PARTIAL LEVEL-09 FRAMING PLAN (PHASE-8) (SEQ#47)

SK#23
17 pages
35 Queries
Date: 07-14-2025

PROJECT DESCRIPTION : 1250 MARYLAND AVENUE

PARTIAL LEVEL-09 FRAMING PLAN (PHASE-8) (SEQ#47)

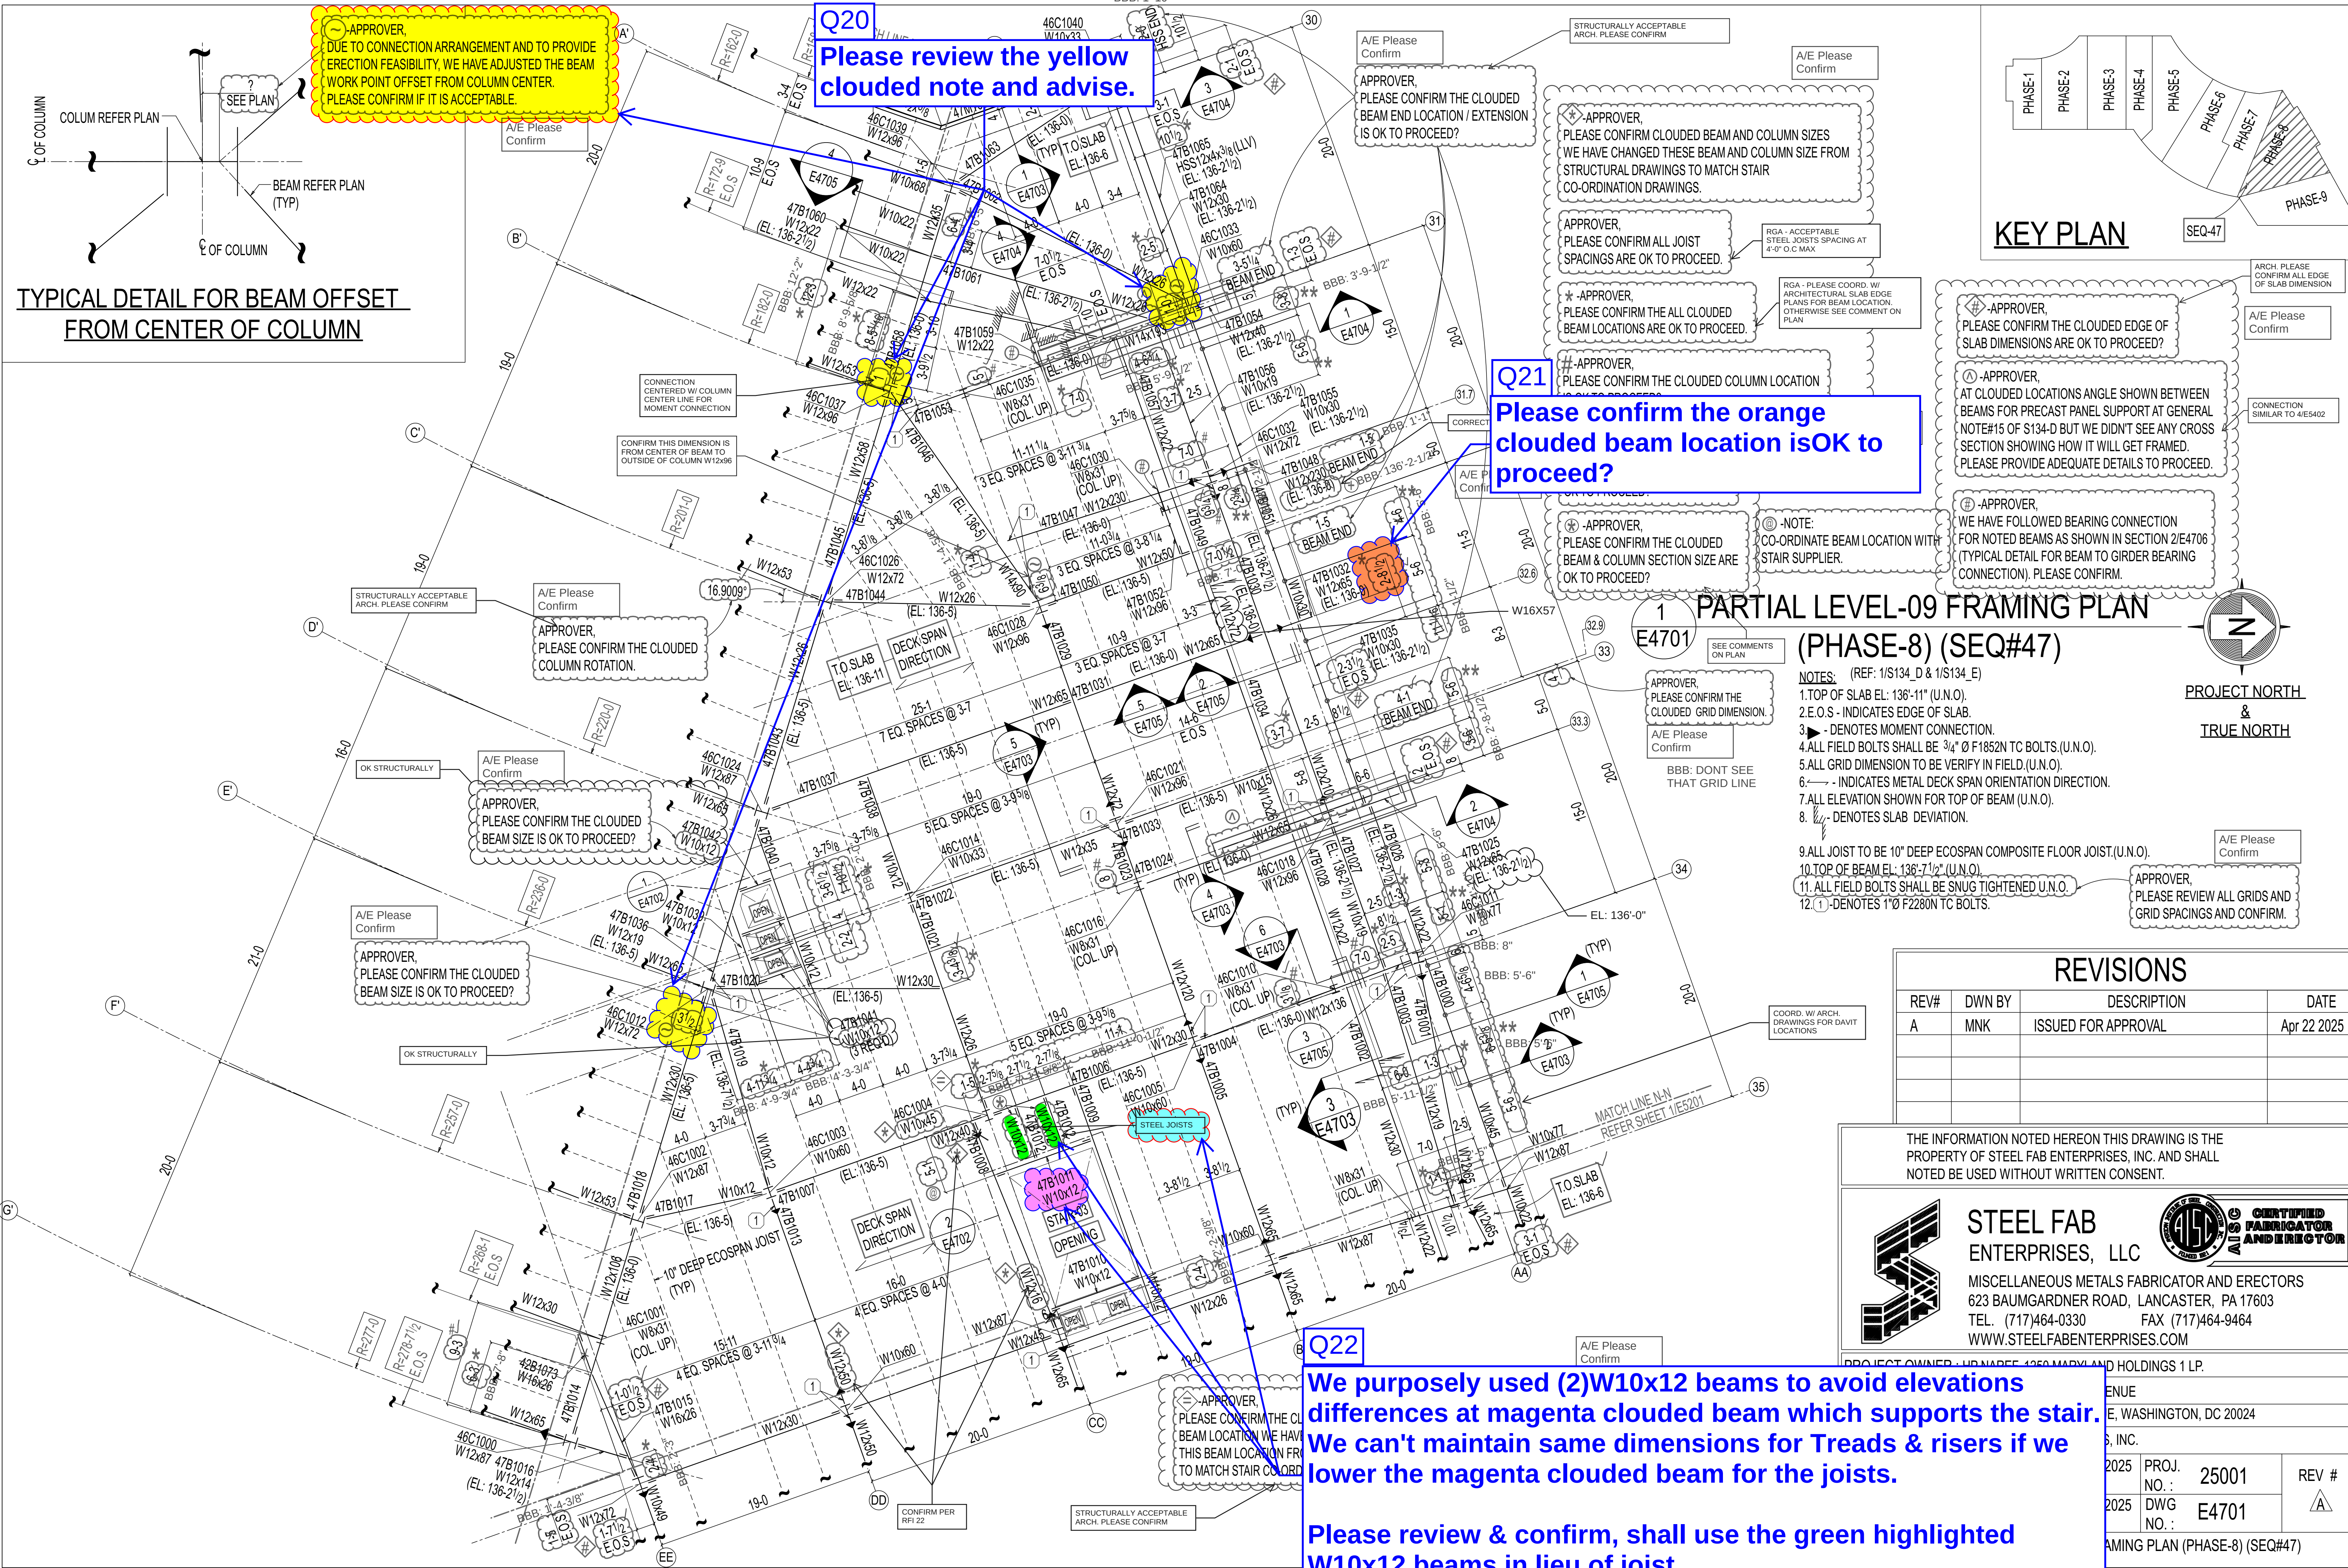
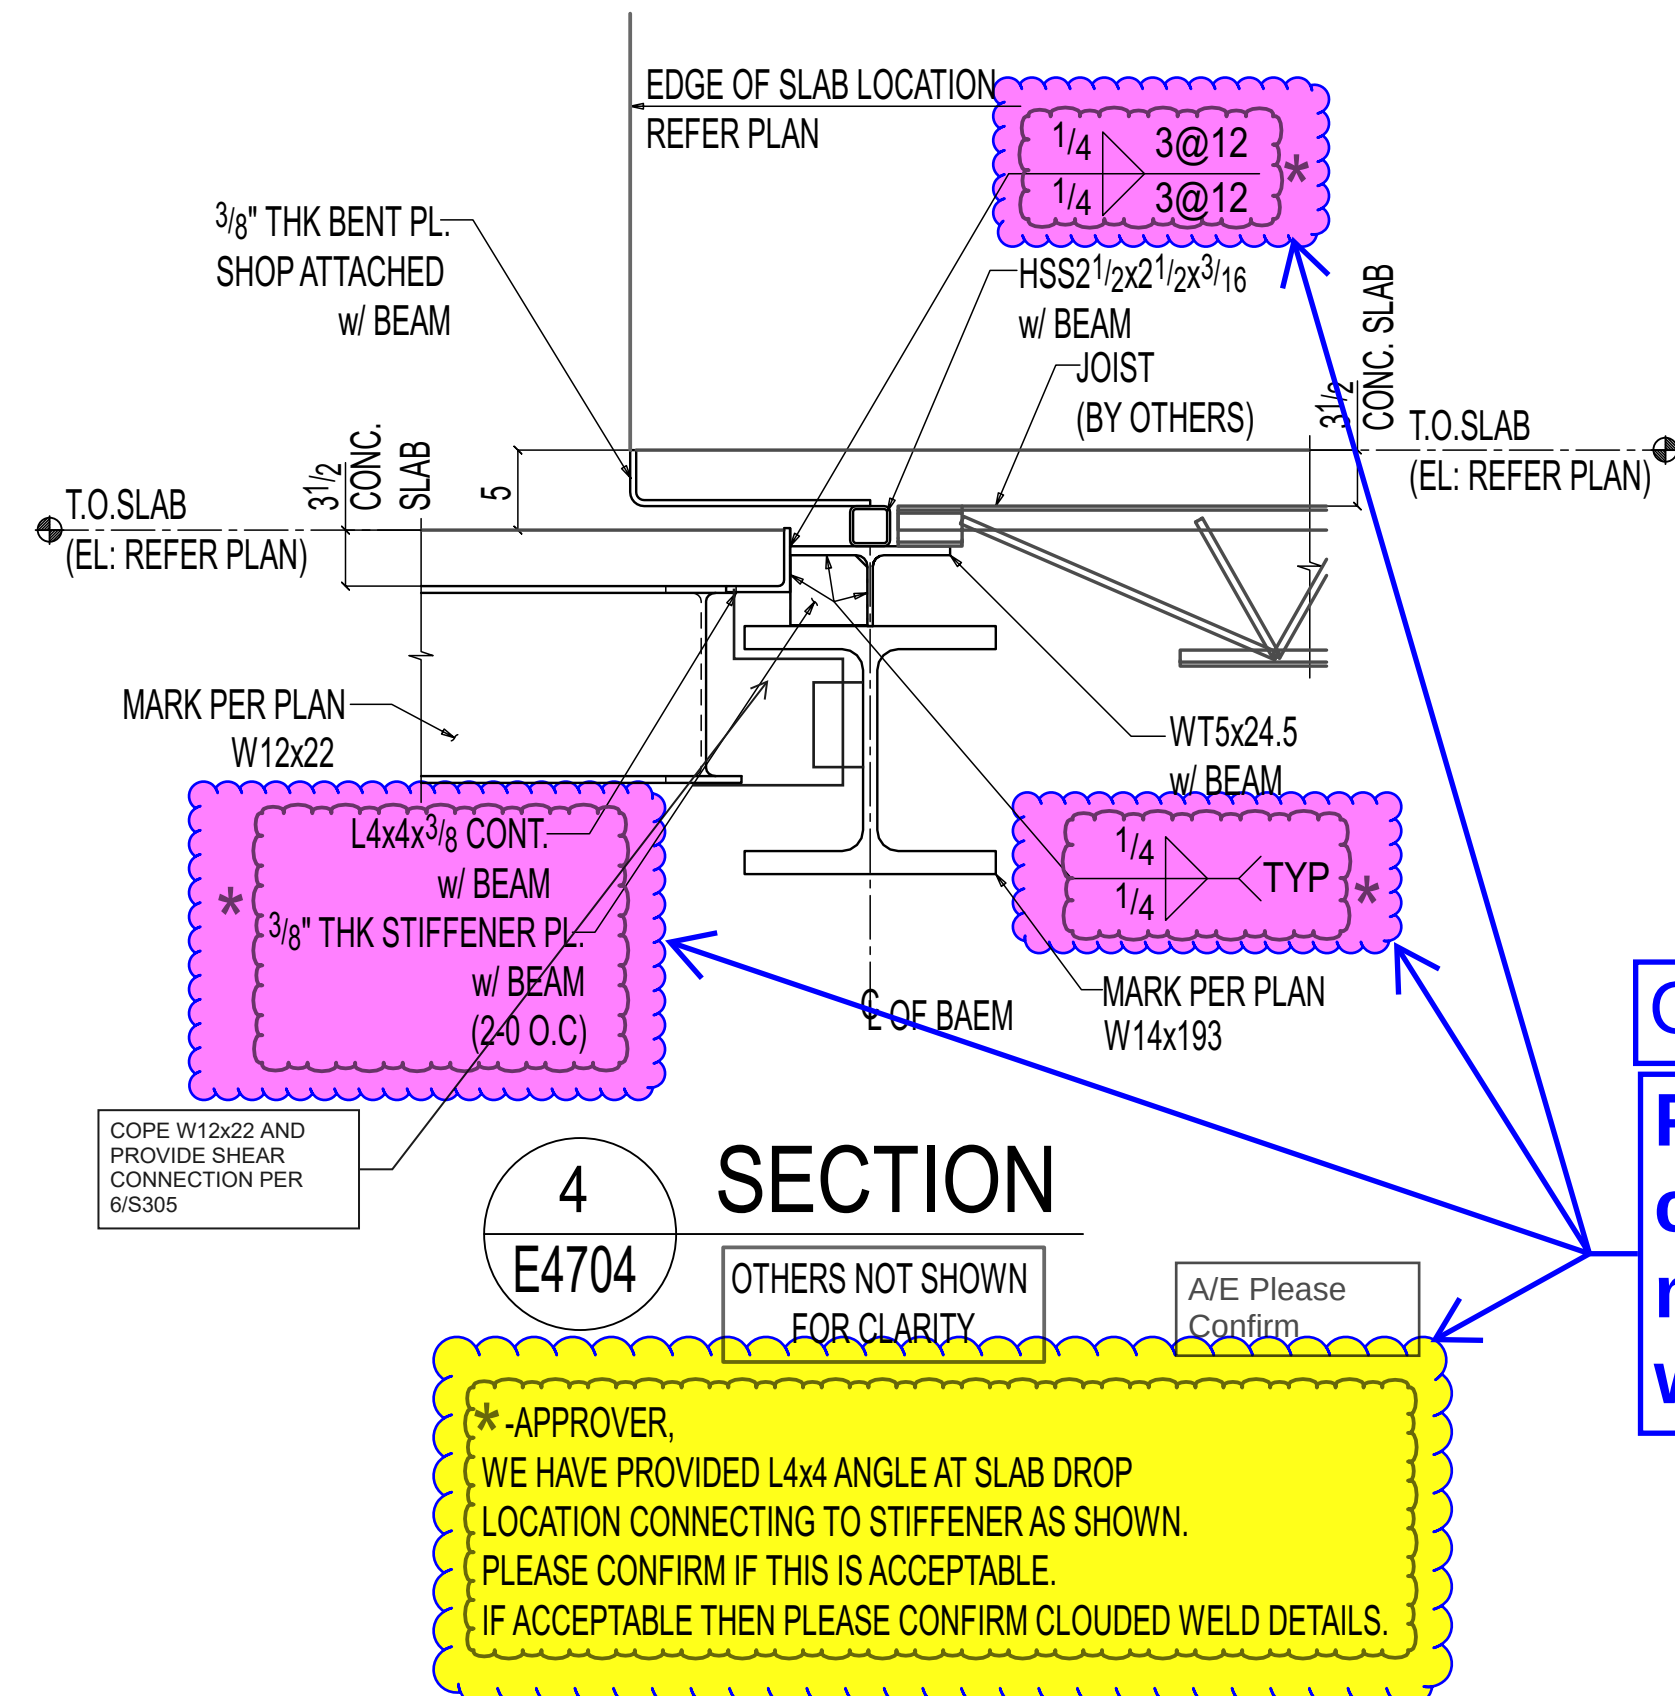
Q20
Please review the yellow clouded note and advise.

Q21
Please confirm the orange clouded beam location is OK to proceed?

Q22
We purposely used (2)W10x12 beams to avoid elevations differences at magenta clouded beam which supports the stair. We can't maintain same dimensions for Treads & risers if we lower the magenta clouded beam for the joists.

Please review & confirm, shall use the green highlighted W10x12 beams in lieu of joist.
